TITLE CENTER OF GRAVITY FOR JB'S 7193 & 7196			PLANT/UNIT BFN UR		
PREPARING ORGANIZATION BFEPCL EMG/BMAP/RI			KEY NOUNS (Consult RIMS DESCRIPTORS LIST) BREAKER REPLACEMENT, CENTER OF GRAVITY, JUNCTION BOXES		
BRANCH/PROJECT IDENTIFIERS BFEPCL0582-RI CD-Q2253-883859			Each time these calculations are issued, preparers must ensure that the original (RO) RIMS accession number is filled in. Rev (for RIMS' use) RIMS accession number 120		
APPLICABLE DESIGN DOCUMENT(S) QIR-CEB-86-086			RO 870529B0023 B22 '870512 102		
SAR SECTION(S) 71A			R L 890810D0020 B22 '88 0806 103		
UNID SYSTEM(S) 253 RI			R 2881019C0012 B22 '88 1016 156		
Revision 0			R 3 B22 '89 1216 126		
ECN No. (for indicate Not Applicable) P0399			Safety-related? Yes <input checked="" type="checkbox"/> No <input type="checkbox"/>		
Prepared Thomas H. Hoyer 7-14-88			Statement of Problem The center of gravity for JB'S 7193 & 7196 needs to be determined.

Title: Center of Gravity for JB'S 7193 & 7196

SUBJECT CENTER OF GRAVITY FOR JUNCTION BOXES 7193, 7194

Figure 1

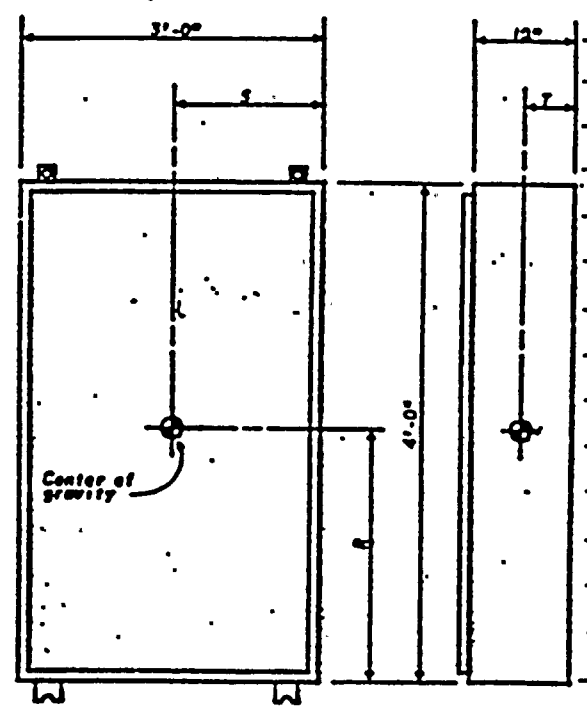
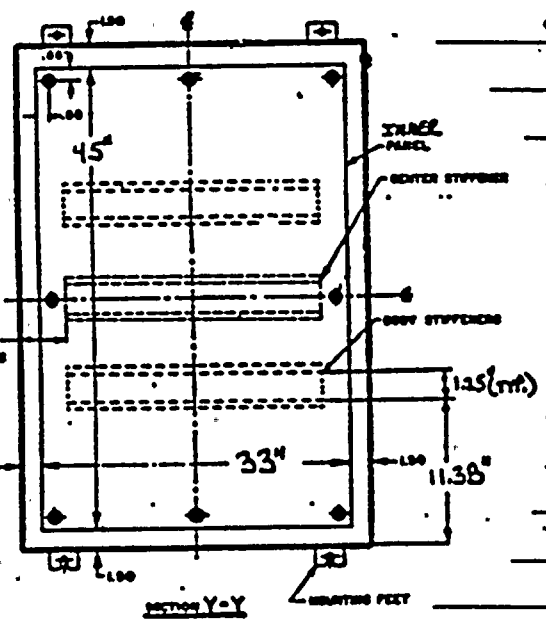
OVERALL CG IS SHOWN ON FIGURE 1. THE CHANGES ARE INSIGNIFICANT. /R3

JB 719
 $R = 21.8'' \text{ } 22.64'' / R3$
 $S = 18.0''$
 $T = 4.0'' \text{ } 4.0''$

Figure 2.

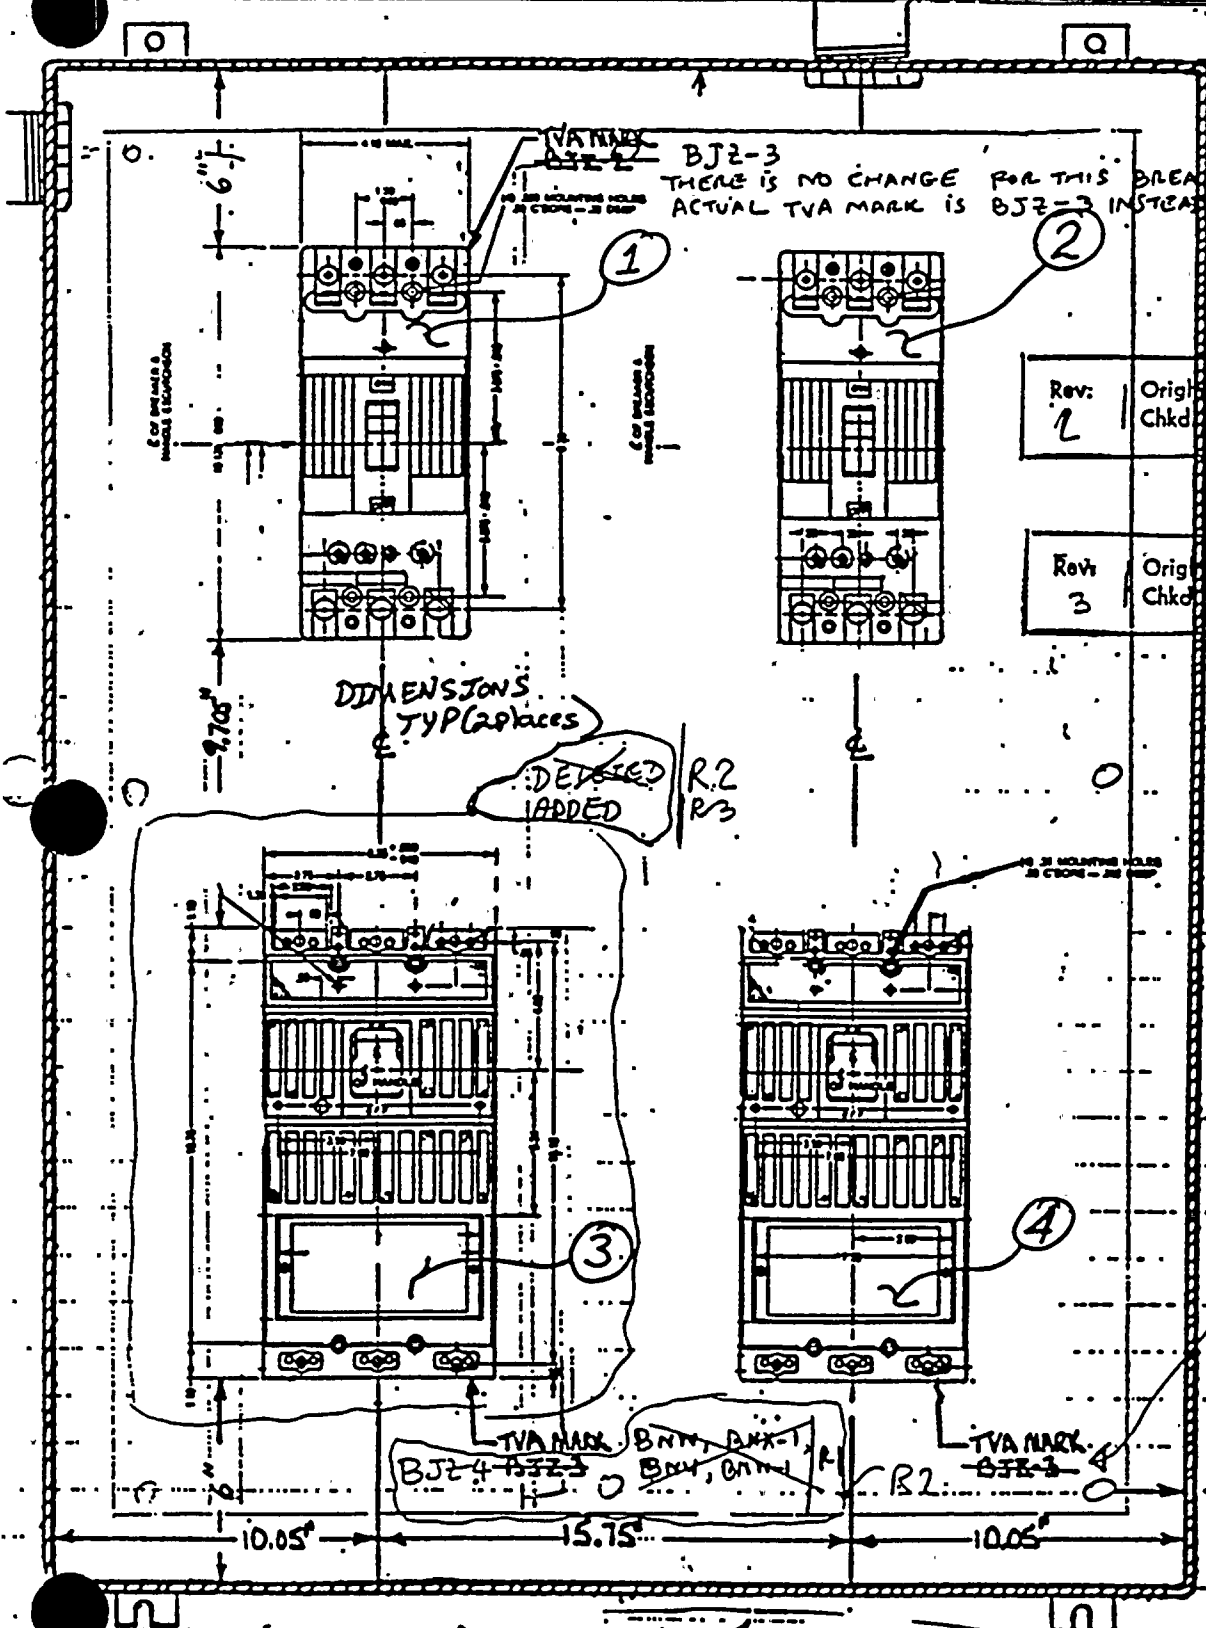
~~BNN, BNX
 BNY, BNW-1~~ R1
 BJE-4.
 R2
 14 CAGE (LOT#)

BJE-4 IS ORIGINAL TVA MARK NOT BJE-3 AS SHOWN R2
